From: Robinson, Derek J CIV USN NAVFAC SW SAN CA (USA)

Subject: RE: The Navy Uncovered Strontium — 90...and they want y...

TABLE 4-3
Summary of Individual Sediment Samples Compared to Their PALs Phase 1, 2a, 2b Data
Addendum to the Feasibility Study Report for Parcel F. Hunters Point Naval Shipyard, San Francisco, California

Figure 1-3
Offsite Reference Background Area
Background Soil Study Report
Former Hunters Point Naval Shipyard
San Francisco, CA

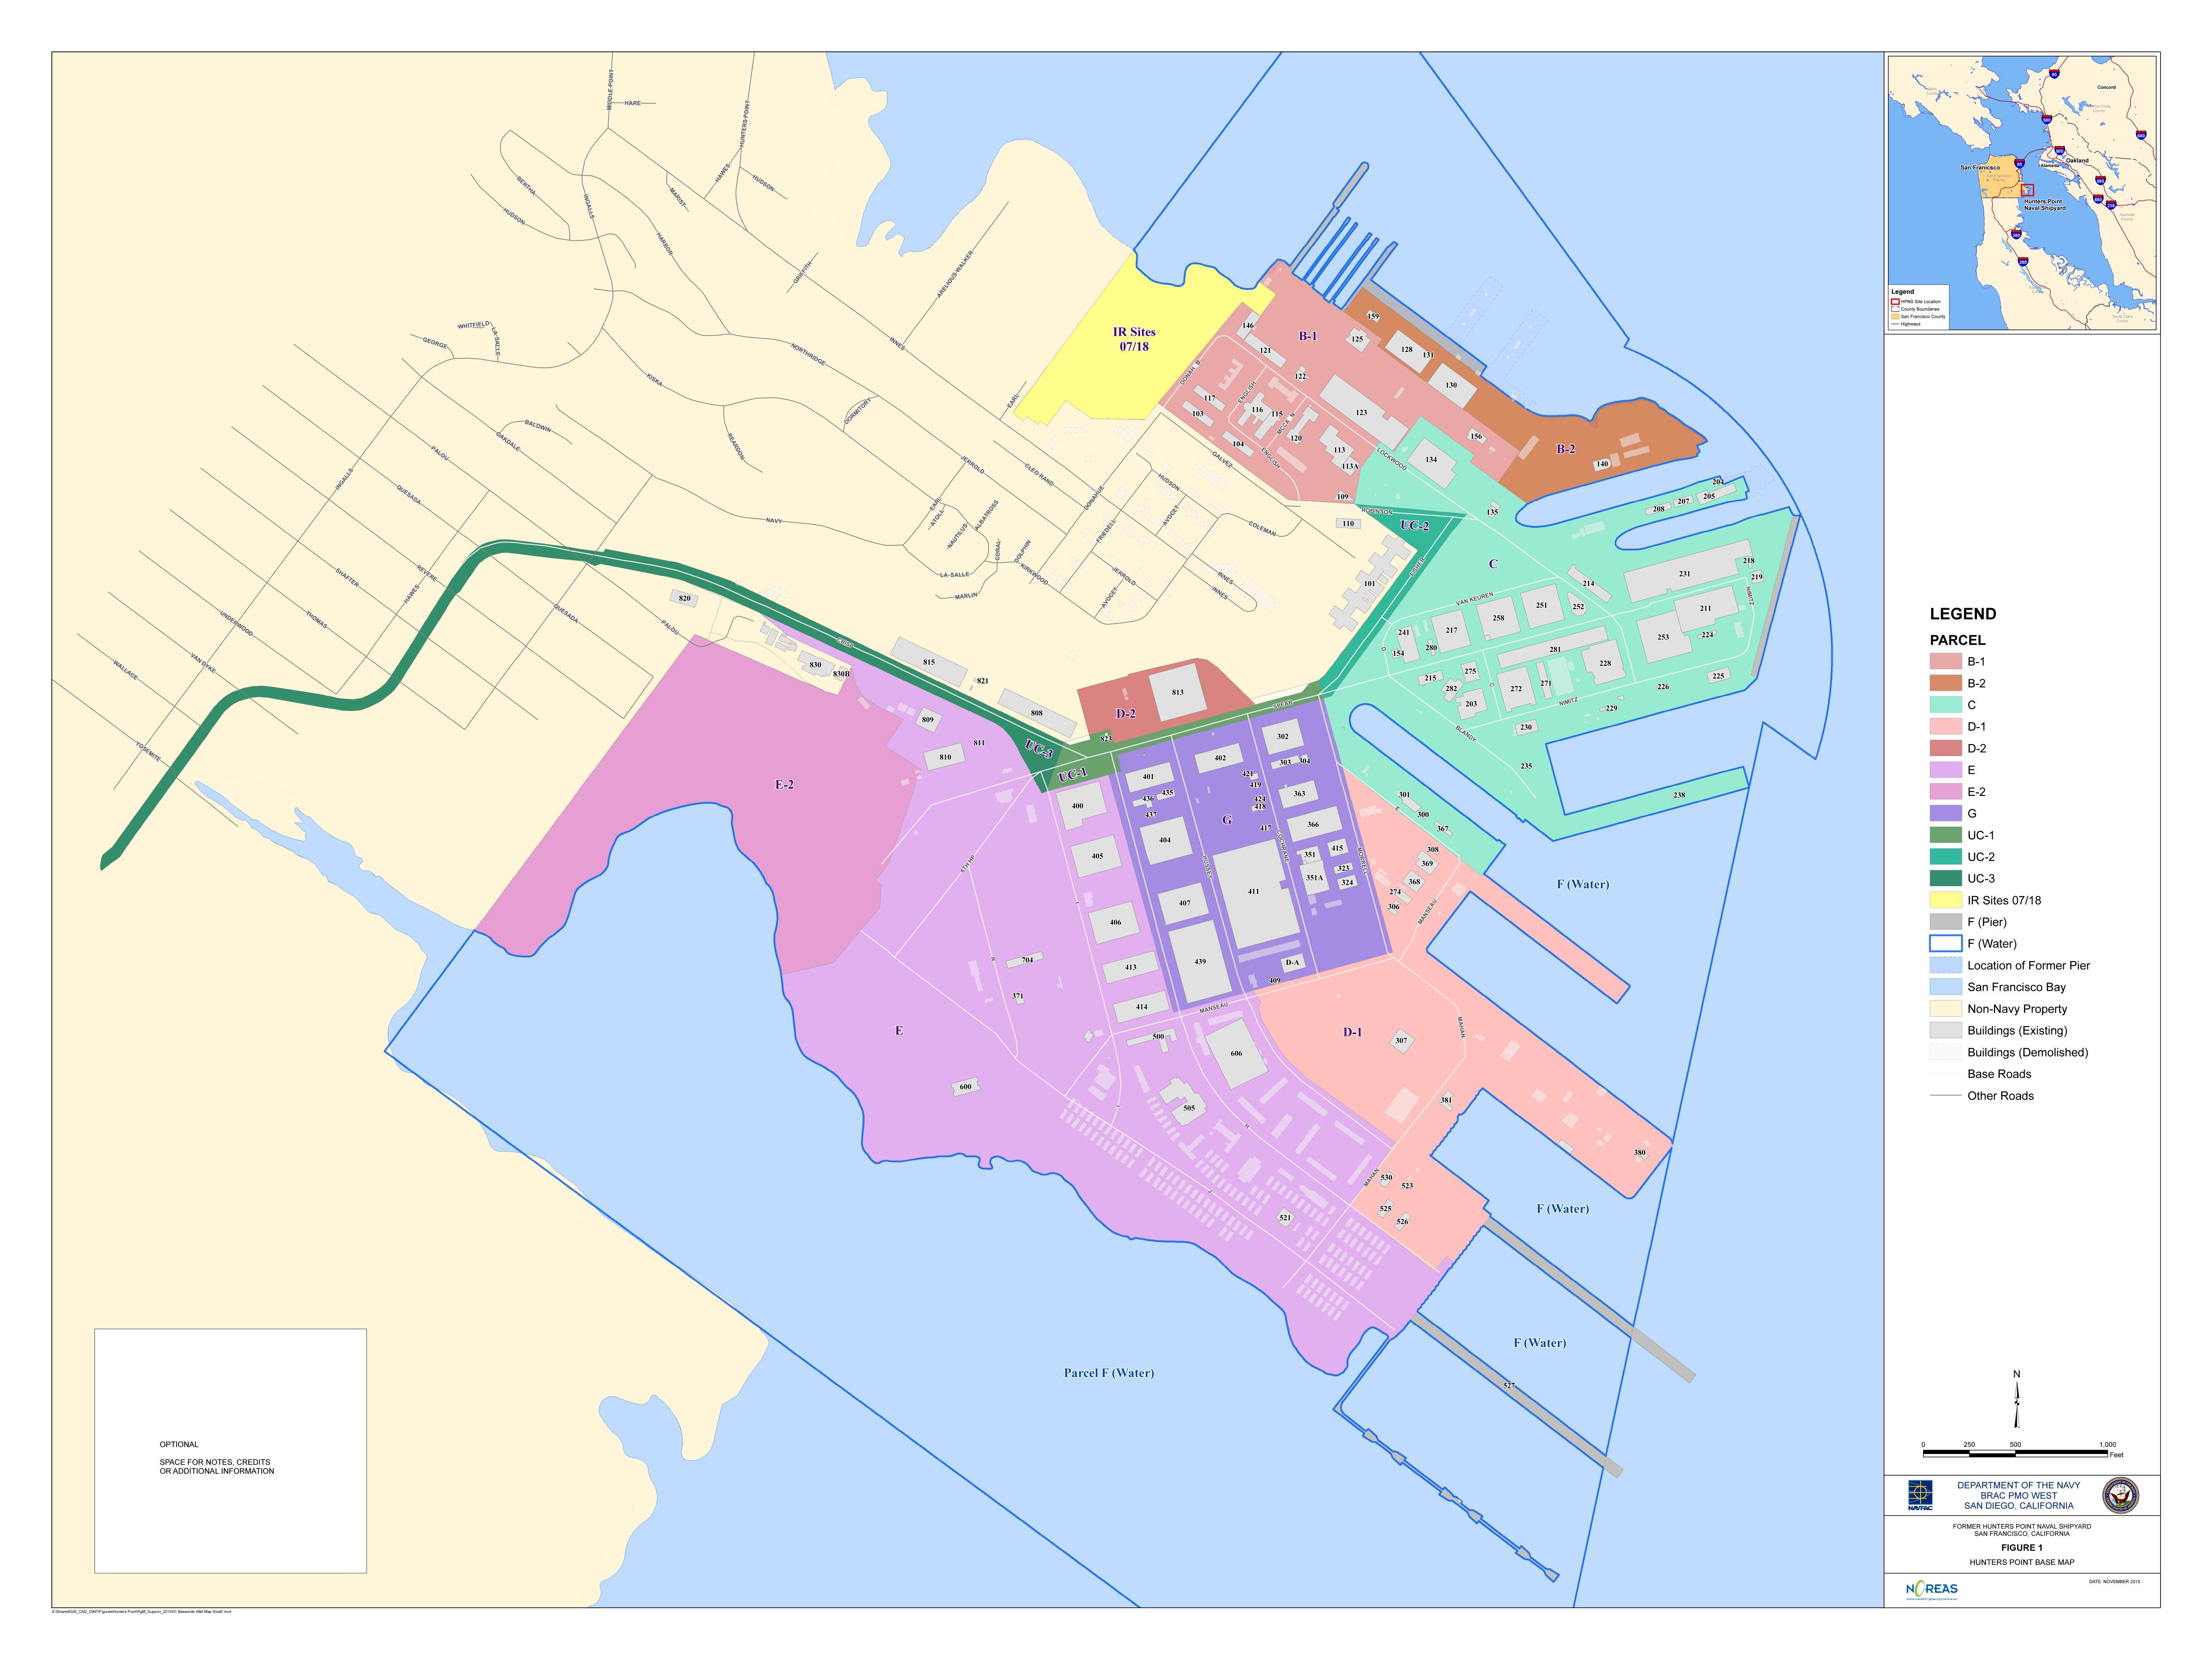
- 4- What background area is used San Bruno Park? I included a map of San Bruno. The idea was to sample an area that included background from fallout. Unfortunately, this location did not seem to have the expected normal background.
